RE: Co-Op Mining Bear Canyon Mine
ACT 015/025 Modification on
Hydrology Design, Monitoring
Locations & NOV Abatement

RE: Proposed Drainage Plan
Lower Seam Portal Area
Bear Canyon No. 1 Mine
ACT/015/025
Emery County, Utah

Drainage Control System
Bear Canyon No.1 Mine
Lower Seam Portal Area

Figure 7-F1

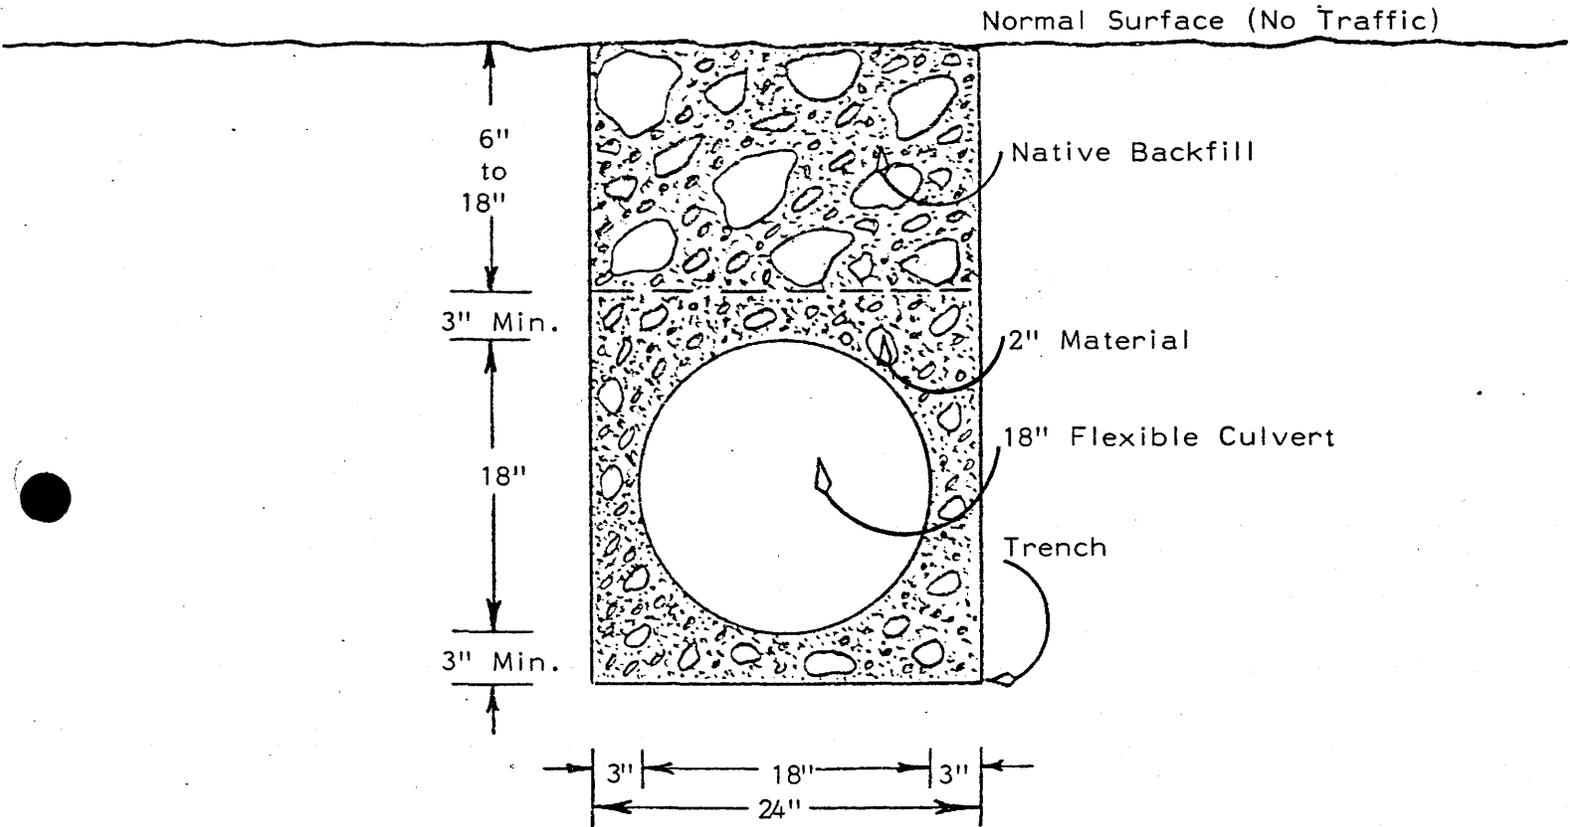
As shown on Plate 2-2, the outslope of the proposed Hiawatha Seam portal pad will encroach upon the ephemeral channel between D-1D and D-2D on Plate 7-8. It is proposed to install a 15" flexible culvert as shown in Figure 7-F1, 7-F2, 7-F3, 7-F4 and 7-F5, and Plate 2-2 to convey the drainage from the upper areas of the channel beneath the pad. The outlet protection for the flexible culvert shown on Plate 2-2 will adhere to the specifications as indicated on pages 83-B3, B4 and page 64-A Bear Canyon MRP. The rip rap and filter blanket specification will be adhered to as specified.

The pad and channel will be constructed prior to placing the flexible culvert in the excavated channel. The culvert will be backfilled and all heavy equipment will be precluded from the area to avoid an accidental crushing of the buried culvert. The flexible culvert is designed to withstand being buried but will not hold up under

Figure 7F-2
DOWNSPOUT STRUCTURE

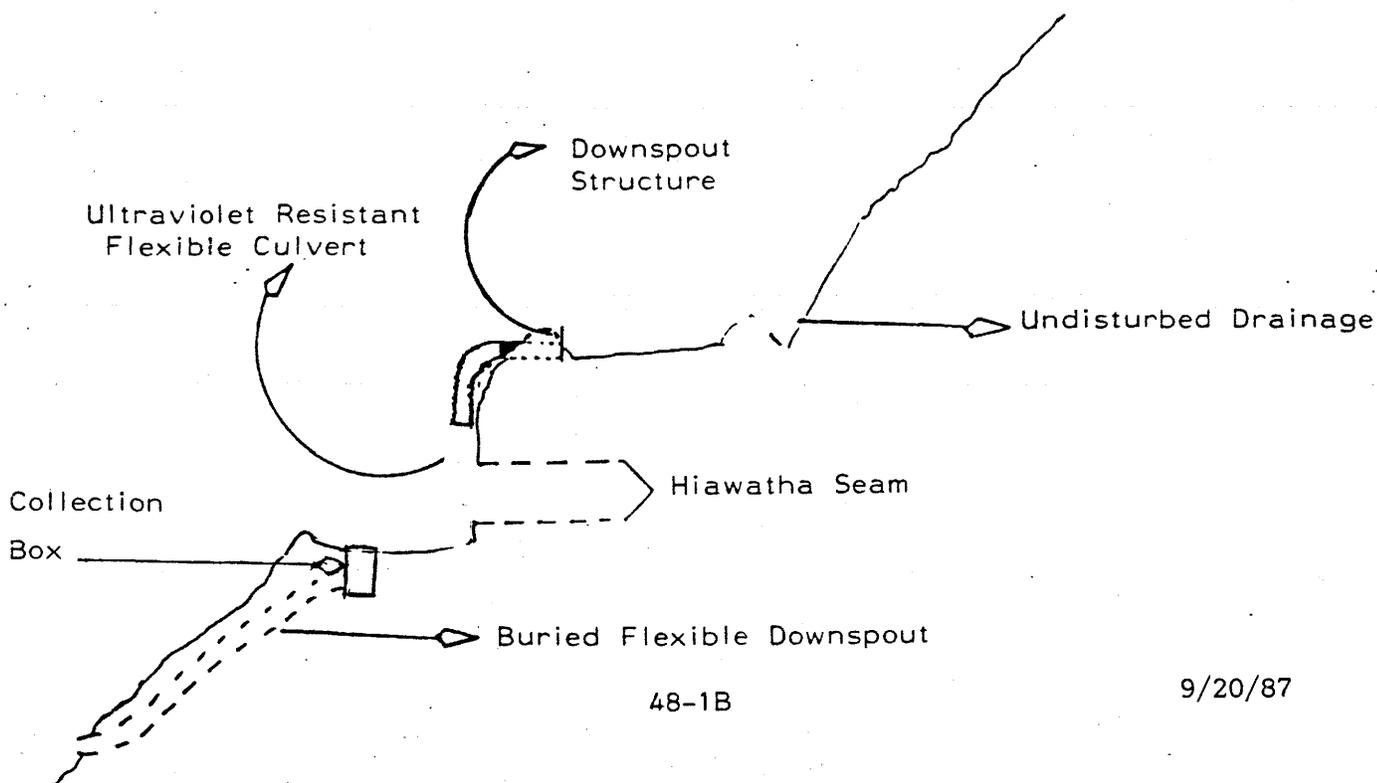
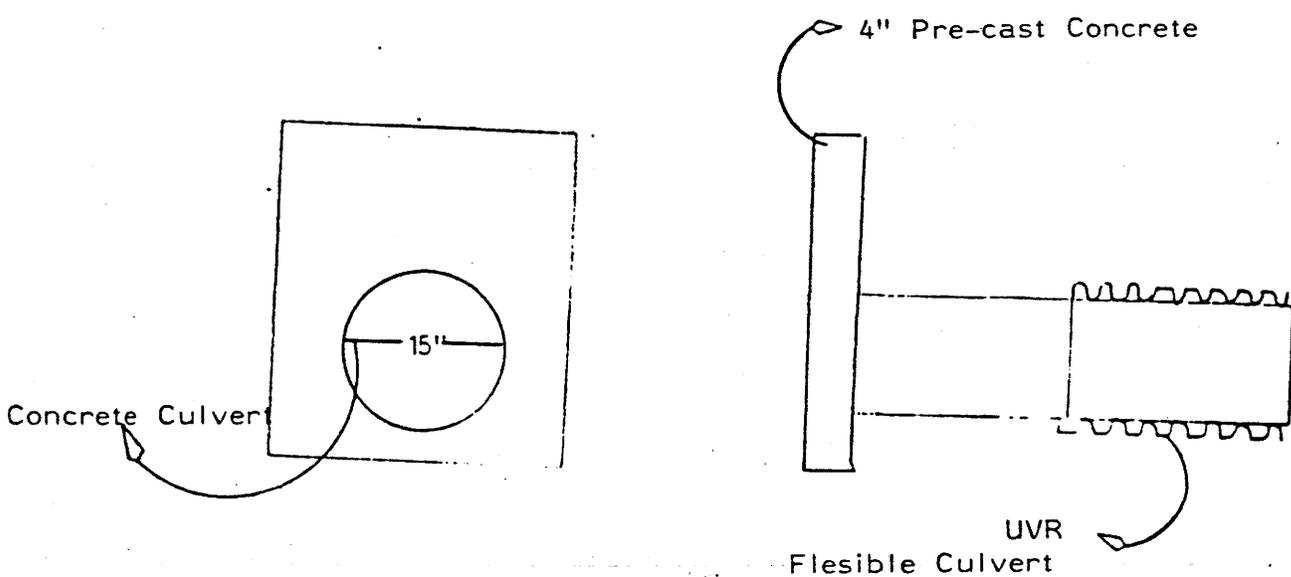
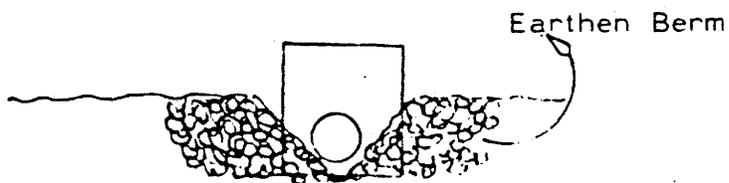
- [3] Flexible Culvert - The collection box at the portal pad will discharge into a flexible culvert with a minimum diameter of 15" [a larger pipe may be used, depending on availability]; the culvert will drop onto the next lower pad area [Conveyor Support Pad];

Figure 7-F3

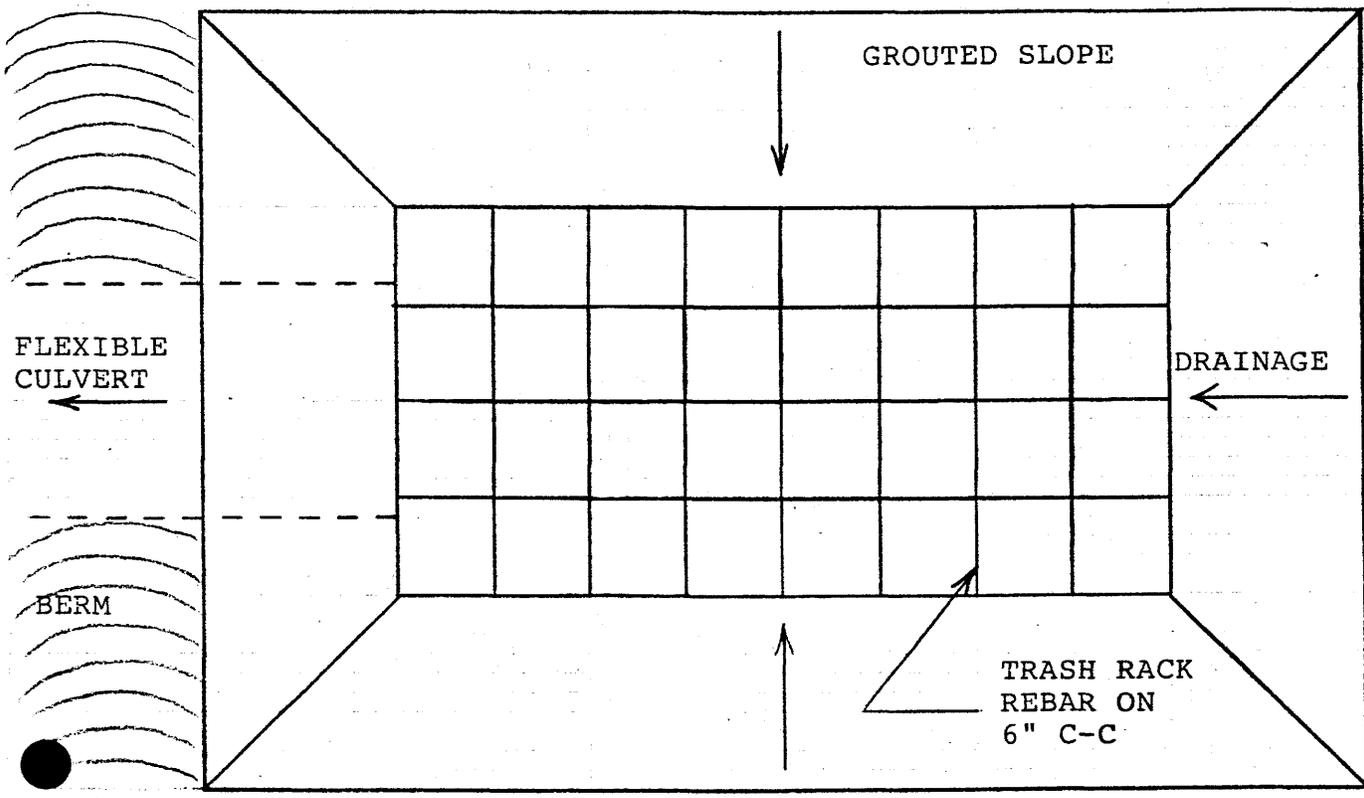
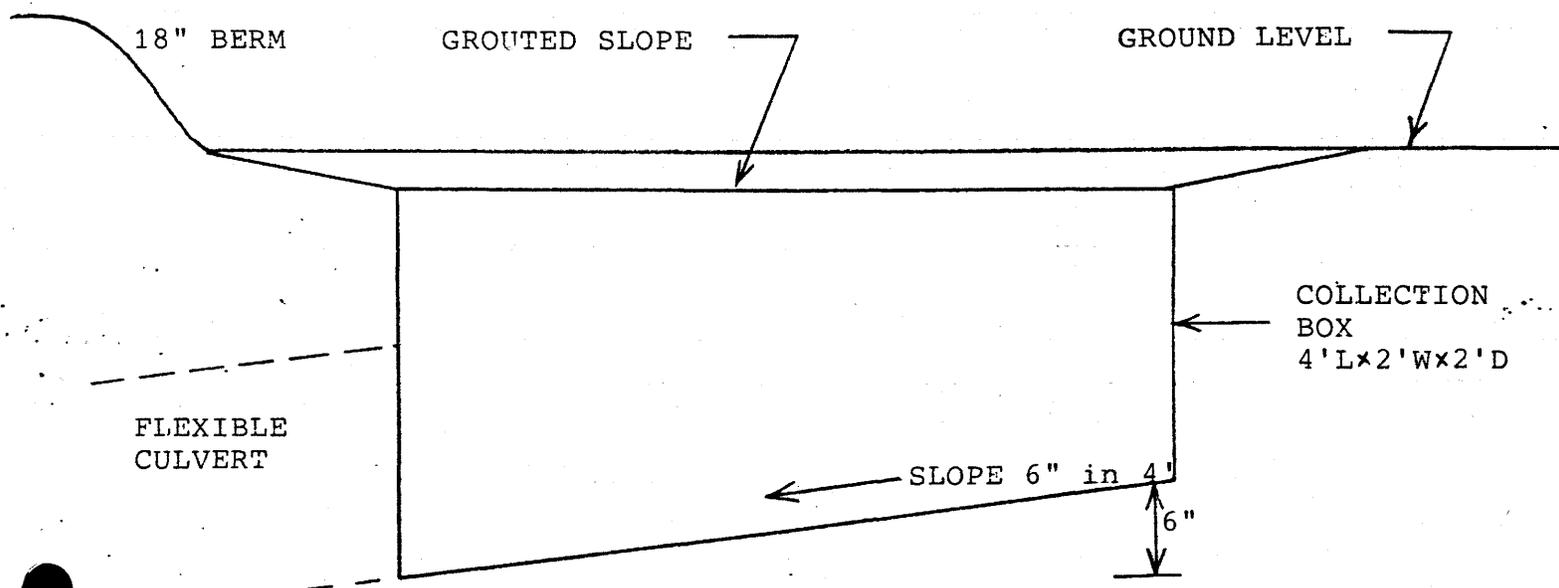
- [4] Conveyor Support Pad - This pad will be sloped to drain to the flexible culvert area; the flexible culvert will be opened [or replaced with $\frac{1}{2}$ round culvert] for a distance of at least 10' to allow surface water to enter the culvert; the entrance to the culvert will be protected by a trash rack and grouted as shown on the attached typical drawing; water will then flow down the flexible culvert to the Coal Processing pad area;

Figure 7-F4

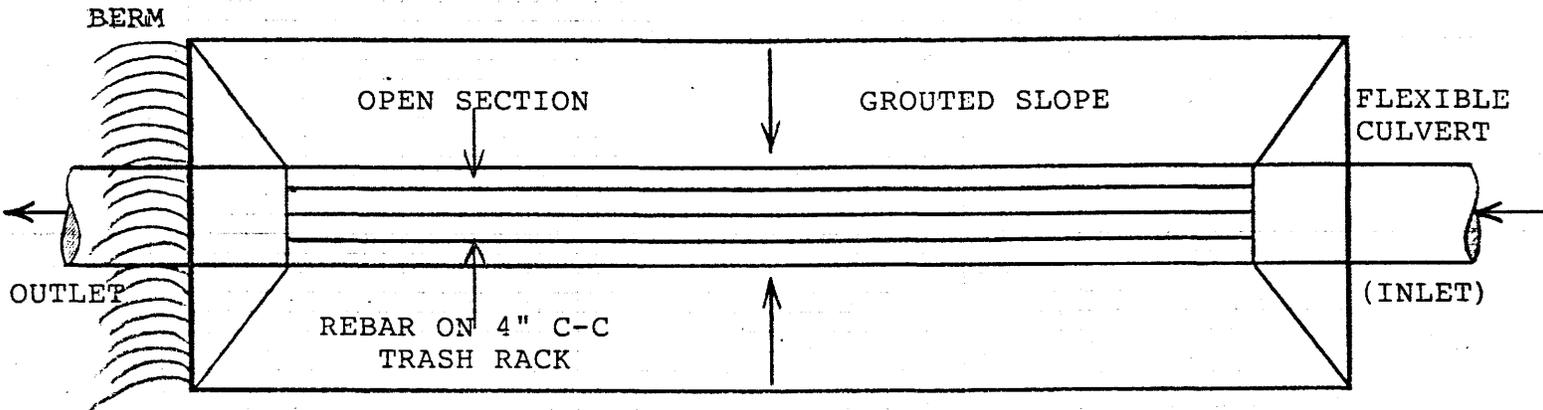
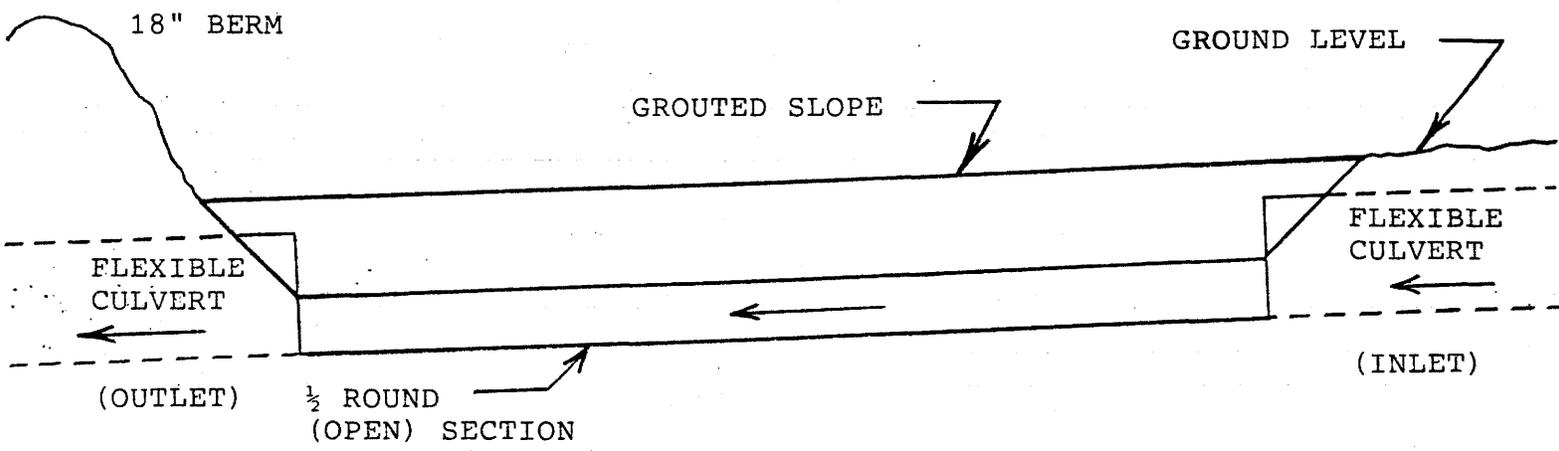
- [6] Lump Coal Pad - The flexible culvert will parallel the conveyor down to the lump coal bin, pass beneath the bin supports, and empty into a catch basin/energy dissipator just south of the bin; runoff will then flow south into ditch D-4D and pass through culvert C-2D and onto Sediment Pond "A".
